United States Department of the Interior

FISH AND WILDLIFE SERVICE
646 Cajundome Blvd.
Suite 400
Lafayette, Louisiana 70506
June 15, 2009

Please reference the Individual Environmental Report 7 New Orleans East Levee, Maxent Canal to Michoud Slip, Orleans Parish, Louisiana (IER 7). That study was conducted in response to Public Law 109-234, Emergency Supplemental Appropriations Act for Defense, the Global War on Terror, and Hurricane Recovery, 2006 (Supplemental 4). That law authorized the Corps of Engineers (Corps) to upgrade some existing hurricane protection projects to provide protection against a 100-year hurricane event. This report contains an analysis of the impacts on fish and wildlife resources that would result from the implementation of 100-year hurricane protection for that area, and provides recommendations to minimize project impacts on those resources.

Figure 2. IER 7 – LPV 108 access channels.

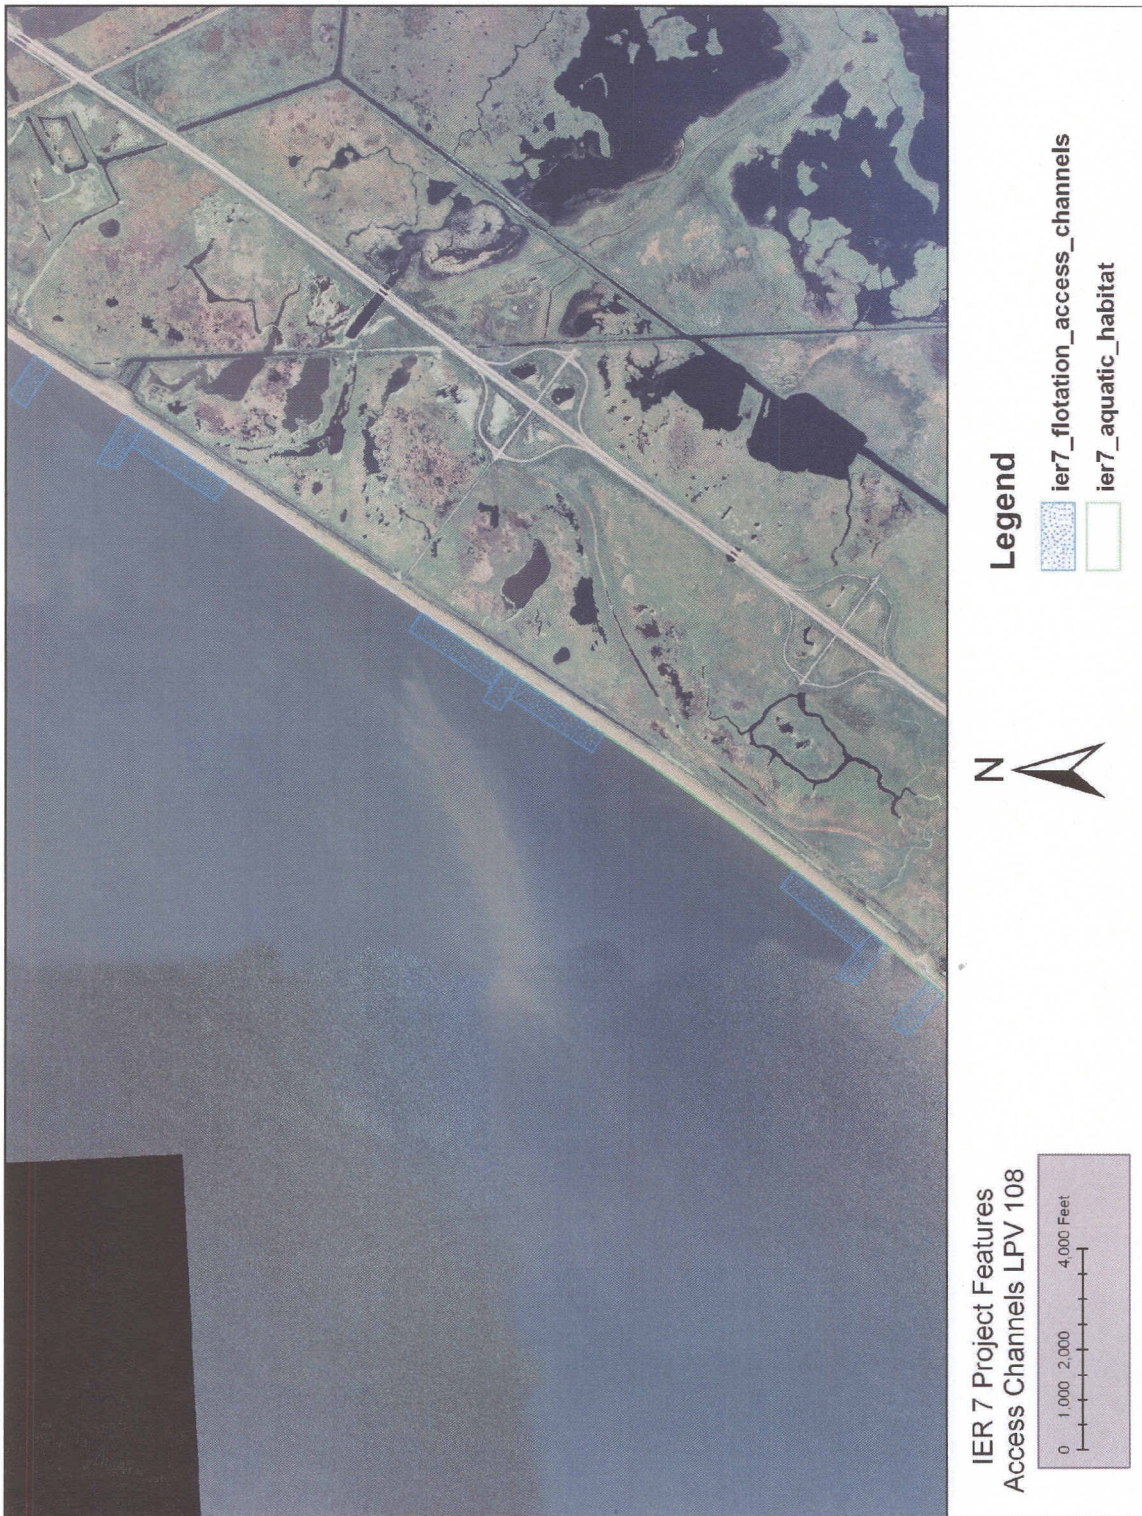
2. Access channels should be refilled up to the prior lakebed elevation after project construction, especially the channel sections in water depths of 3 feet or less. Post-construction surveys (e.g., centerline surveys) should be taken to ensure access channels have been adequately backfilled. That information should be provided to the natural resource agencies for review. In areas shallower than 3 feet, where pre-existing elevations have not been successfully restored, the Corps should ensure those elevations are restored by additional measures
